\*\* Please find our point-by-point response highlighted in blue to the reviewer's comments.

**Response to Referee #1: Adam Emmer**

## Response to Referee #2

**Fig 2.** Study area and 21 identified dangerous glacial lakes each with a unique lake number, and potentially impacted hydropower plants.

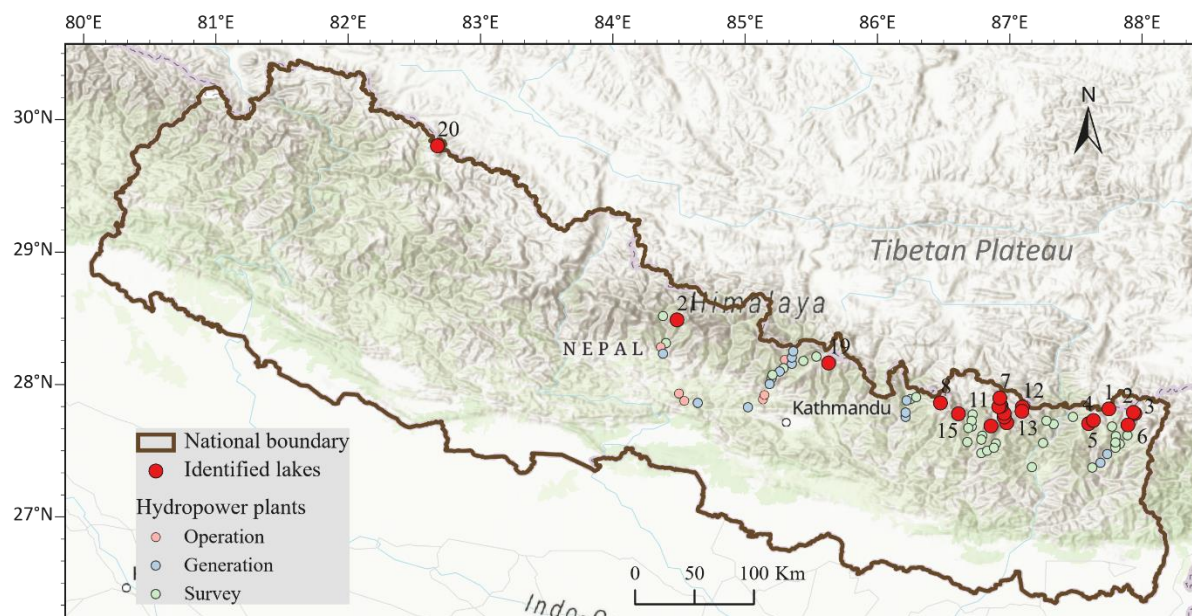
First, the authors have deleted the introduction of the three categories of glacial lakes in the text but the classification still remains in Fig. 2. I suggest to remove the classes of the lakes in this figure. Instead, the authors can mark the lake numbers in Fig. 2, if possible. The risk classification of the lakes is also seen somewhere in the text, e.g., in section 4.3.3. The authors need to go through the paper to remove the classification in the text.

Besides, the hydropower stations listed in Table 4 can also be shown in Fig. 2 to visualize the exposure of these hydropower stations to GLOFs. Further information is better to be shown in Table 4, e.g., capacity, commission/issue date, corrected longitude and latitude, how impacted by nearby glacier lake(s). Lines 425-429 should be moved to the methods section, combined to the paragraph from line 256 to line 272. The paragraph in lines 425-429 also needs to be shortened. For instance, the sentence in lines 430-433 can be rewritten if the information is shown in Table 4 somehow.

**Response:** Figure 2, shown below, has been improved based on the reviewer's comments. The risk classification of the lakes has been reviewed and removed from the draft.

Response: These hydropower stations have been added to Figure 2, and detailed information such as capacity, commission/issue date, corrected longitude and latitude, and the lake(s) that may pose risks have been included in Table S1 of the supporting document. The original lines 425–429 have been moved to lines 270–272. The paragraph in lines 425–429 has been shortened as follows.

Fig 8 Damage to buildings, roads, and agricultural land caused by the most serious GLOF due to Lake Anonymus 12

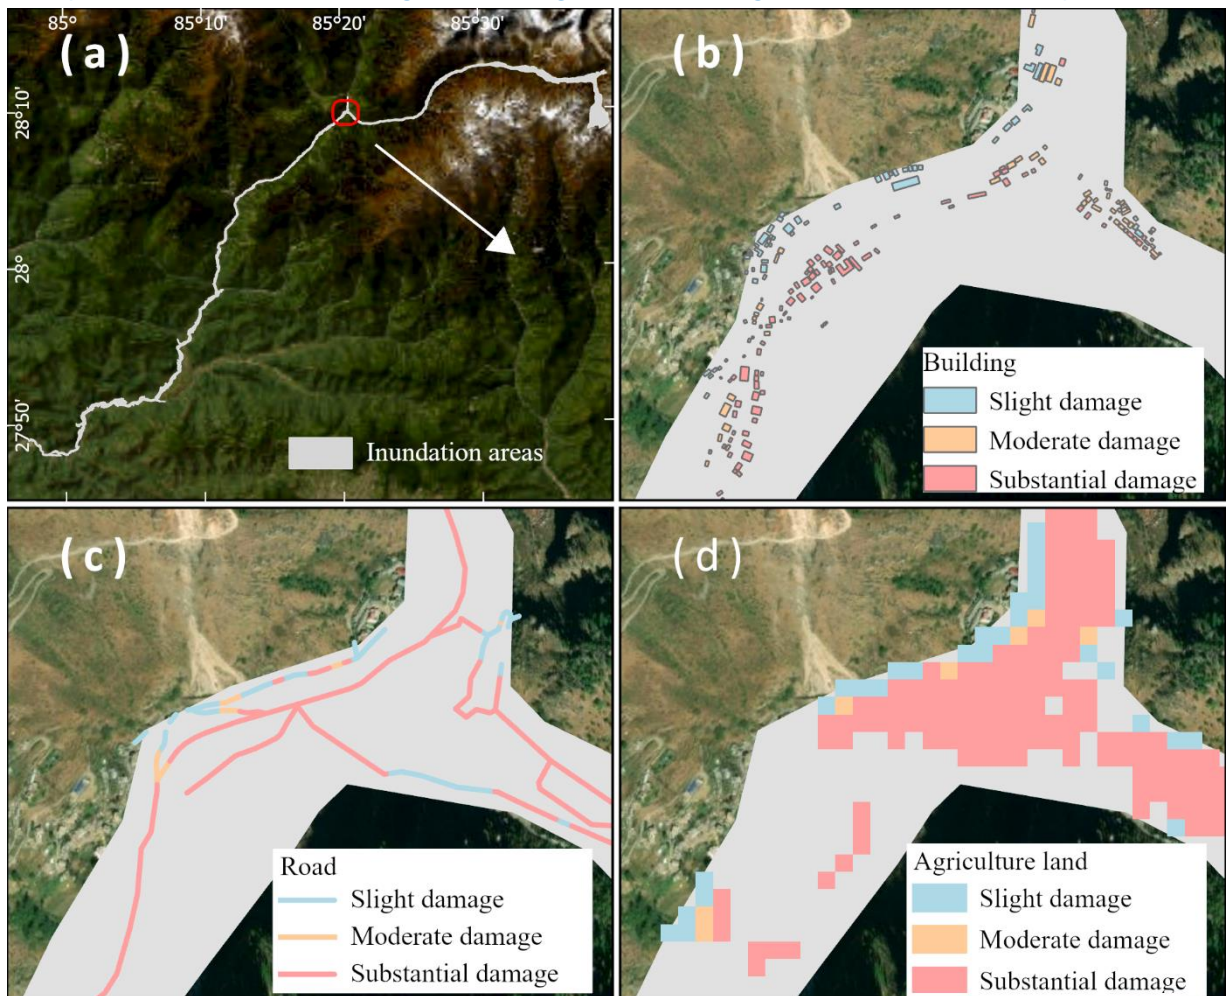
Last, the authors showed the statistics on the damage to buildings, roads and agriculture land caused by GLOFs, but did not visualize the spatial distribution of this damage in the areas subjected to GLOFs. Maybe this has been shown in previous work of the authors, but providing some examples of the damage maps will make the advantages of the advanced hydrodynamic simulating technique clearer to the audience. The authors can consider to provide such examples in appendices or supplementary material if putting them in the main text is inappropriate.

Response: An example figure has been added. Figure 8 uses Lake Anonymus 12 to illustrate the spatial distribution of damage to buildings, roads, and agricultural land caused by GLOFs.
